MIAMIBEACH
PLANNING DEPARTMENT
Staff Report & Recommendation

Historic Preservation Board

SUBJECT: HPB25-0656, **1600 Washington Avenue**

An application has been filed requesting a Certificate of Appropriateness for the total demolition of two structures and the construction of a new mixed-use building.

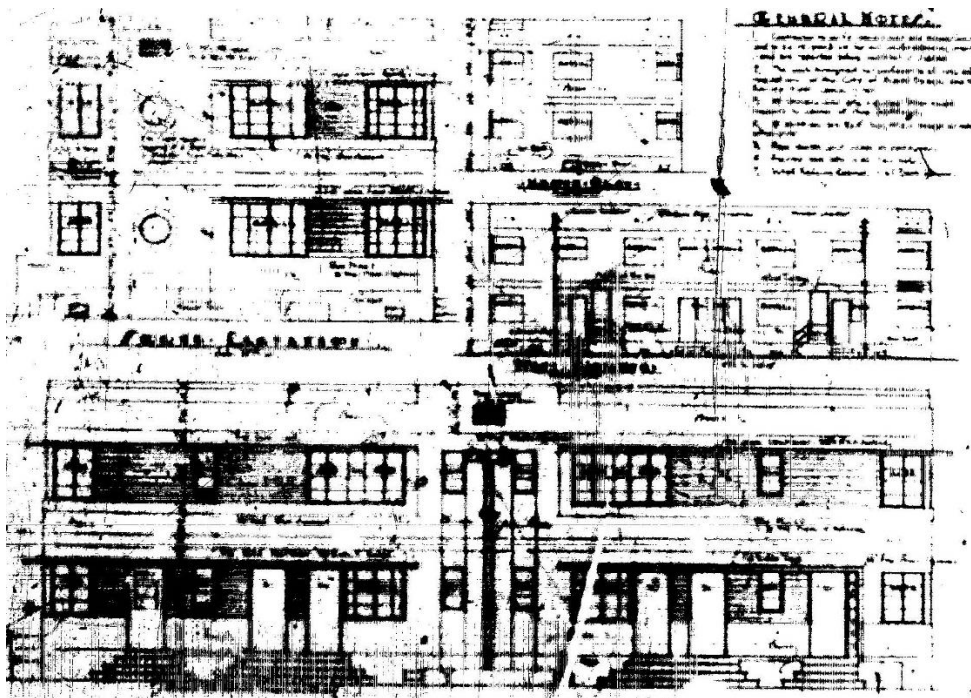
The project includes the total demolition of the existing 1-story Non-Contributing building located at 1600 Washington Avenue as well as the total demolition of the existing 2-story Contributing building and the construction of a new 15-story ground level addition containing 210 residential units and approximately 7,000 SF of retail space on the ground floor. The existing parking garage will be retained and incorporated into the new mixed-use development.
